HYATT HOTEL

Hyatt Regency Tucson Convention Center Hotel
Property Development Zone

Historic Landscape Plans Review Subcommittee and Rio Nuevo Area

Development Package NEW

DRAWING NO. **L3.1**
SHEET NO. 14 OF 22

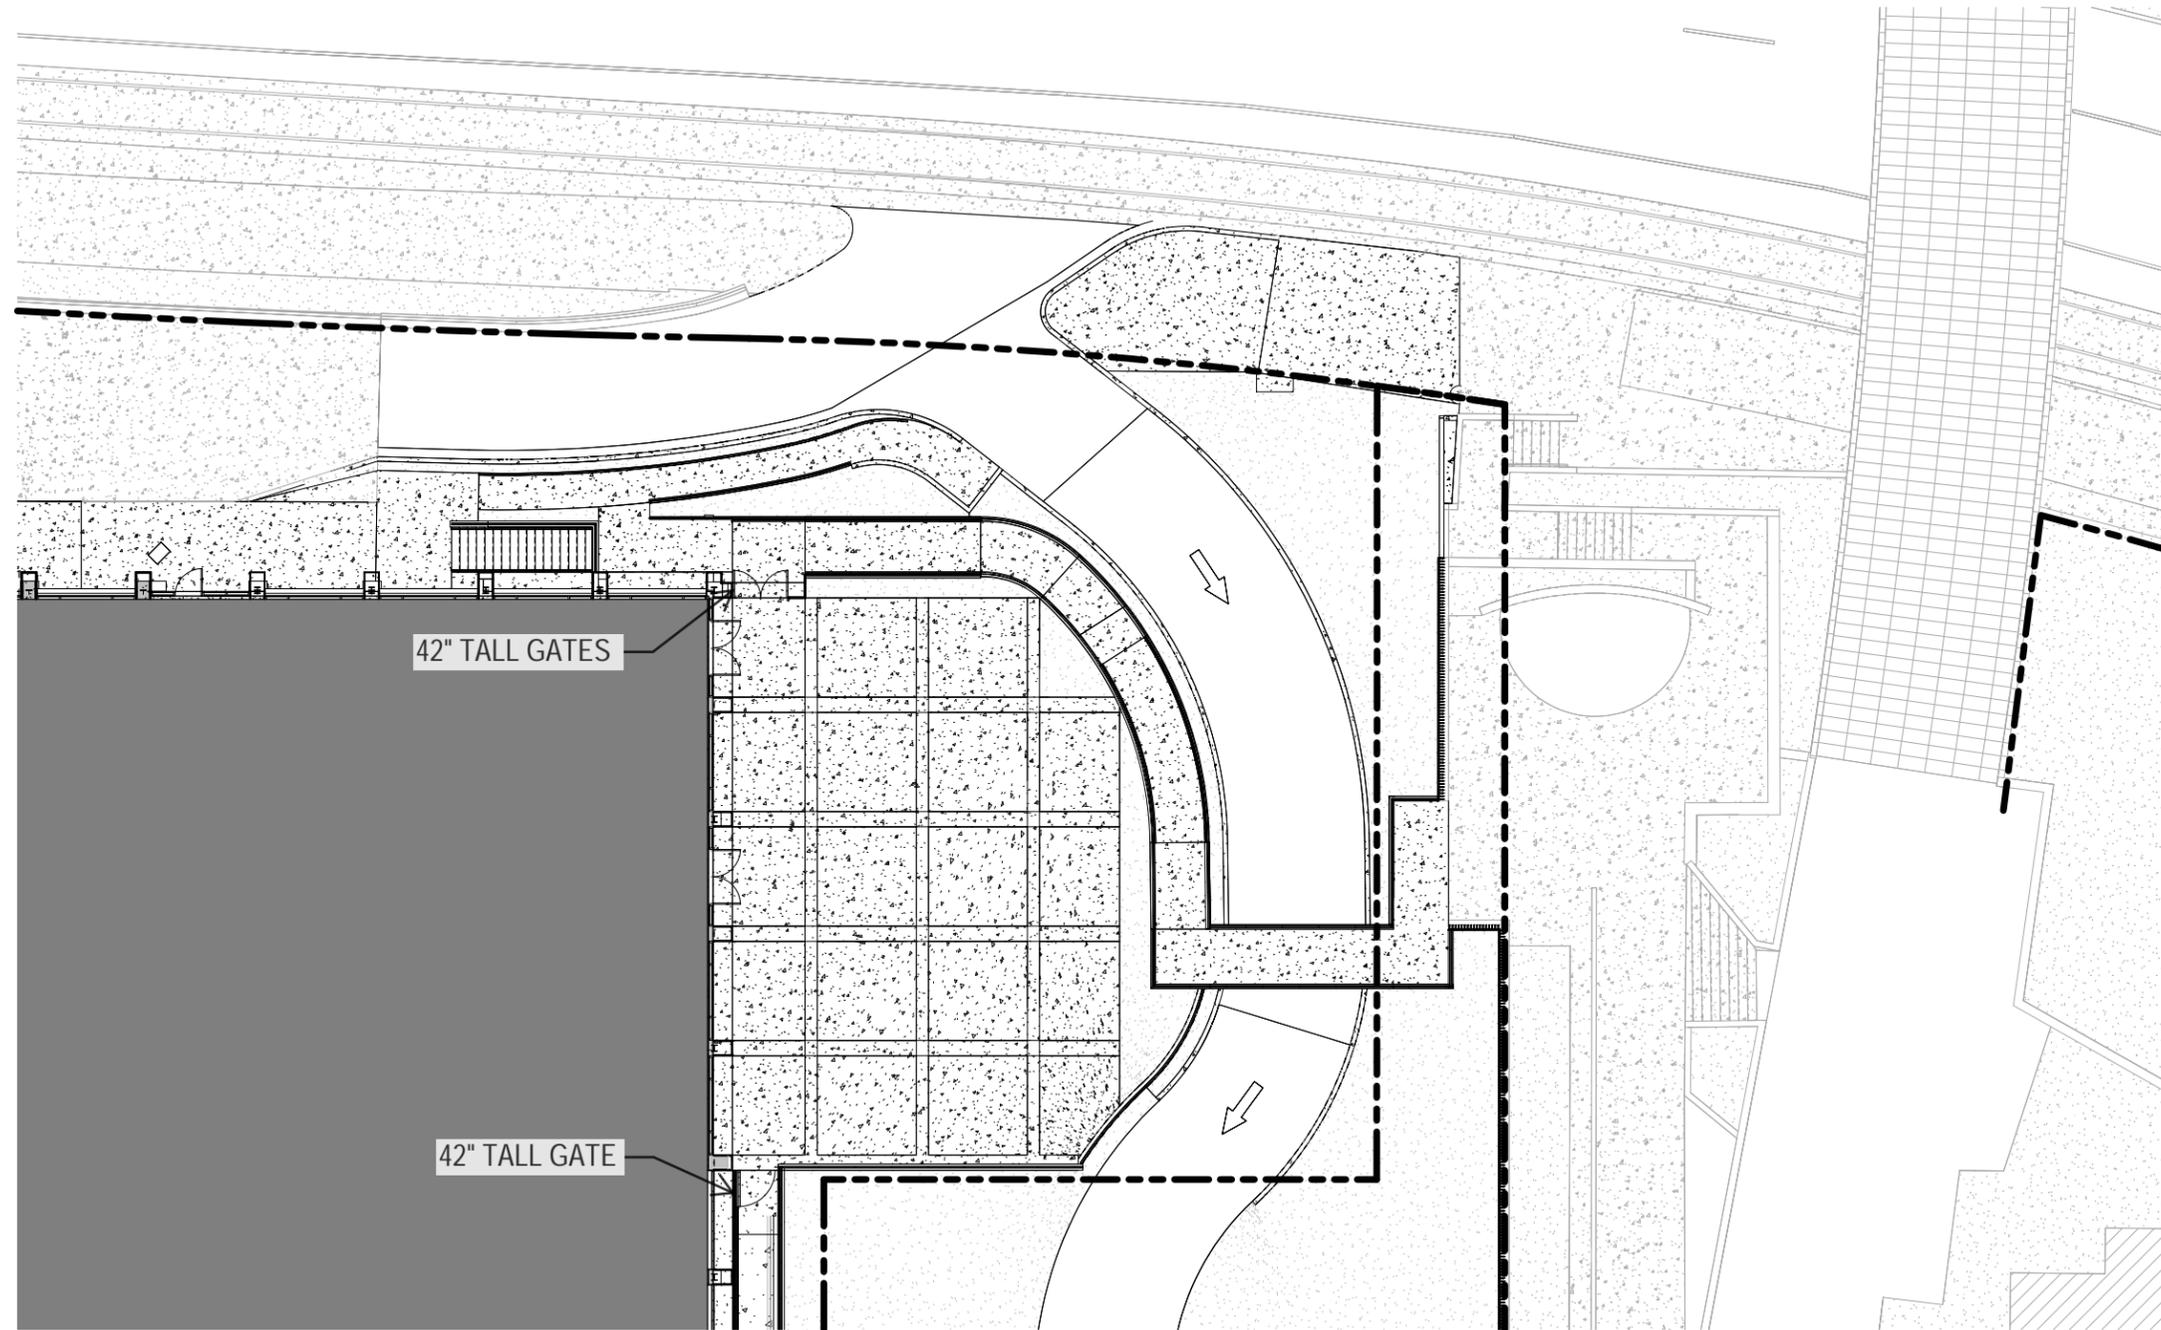
(1) Sheet L3.1. Show the location of fire dept connections on the drawings. There needs to be a minimum 36" clearance around the connections from any obstructions, including vegetation/landscaping. IFC 912.

10 SHADE STUDY

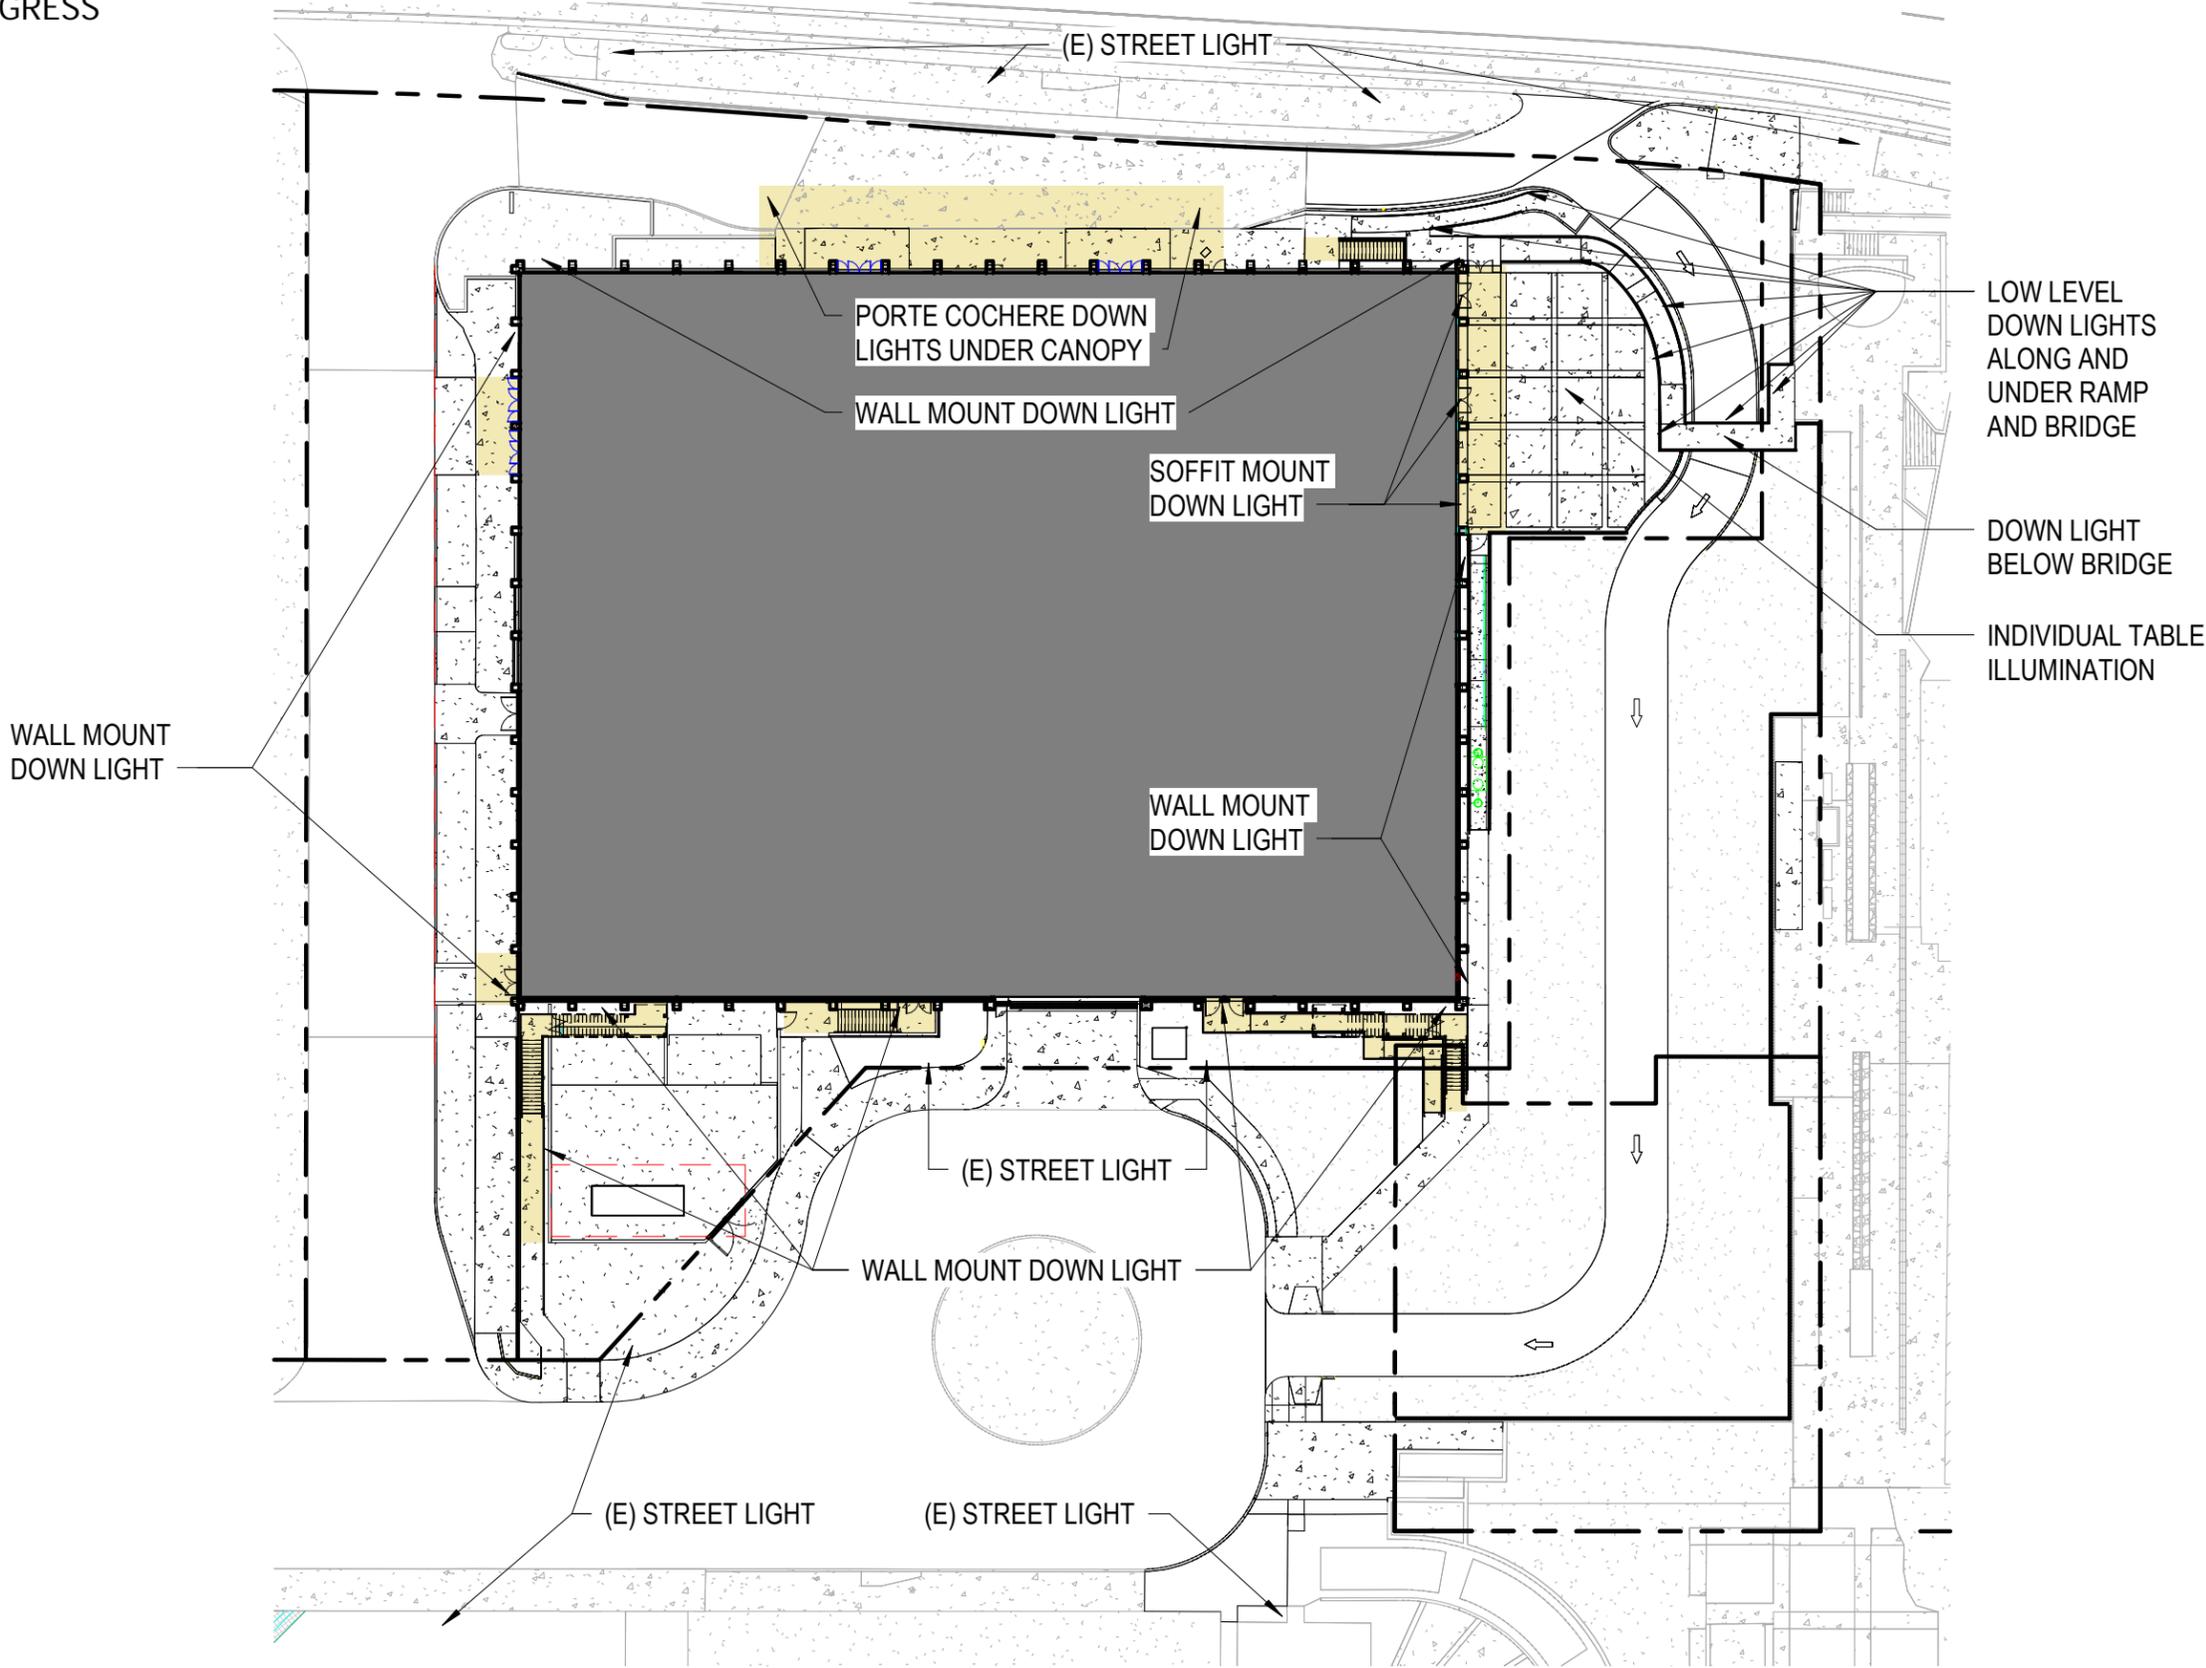
- b. Shade shall be provided for at least 50 percent of all sidewalks and pedestrian pathways as measured at 12:00 p.m. on June 21 when the sun is 82° above the horizon (based on 32°N Latitude). Shade may be provided by arcades, canopies, or shade structures, provided they and their location and design characteristics are compatible with the historic and design context of the street and the architectural integrity of the building. Deciduous trees, as proposed in the Downtown Comprehensive Street Tree Plan, are encouraged to supplement existing evergreen trees. The use of plantings and shade structures in the City right-of-way are permitted to meet this standard with the approval of the Department of Transportation. The shade provided by a building may serve to meet this standard. [See attached shade study.](#)
